REMARKS

AMENDMENTS TO THE DRAWINGS

Please delete Figs. 1-5, 8-10 and 20 originally filed with the application. Please replace originally filed Figs. 6, 7 and 11-19 with the enclosed four Replacement Sheets of drawings renumbered as Figs. 1-11, respectively.

FIG. ~~7~~ 2

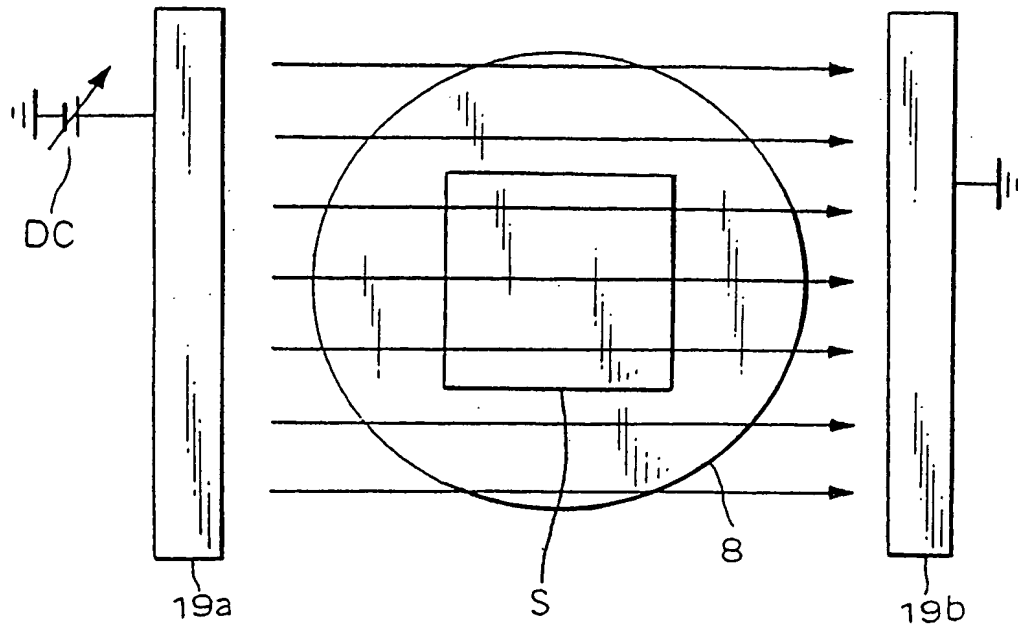
Annotated marked-up drawings of originally filed Figures 1-29 are also enclosed which show annotated revisions which result in the enclosed Replacement Sheets of Figs. 1-11.
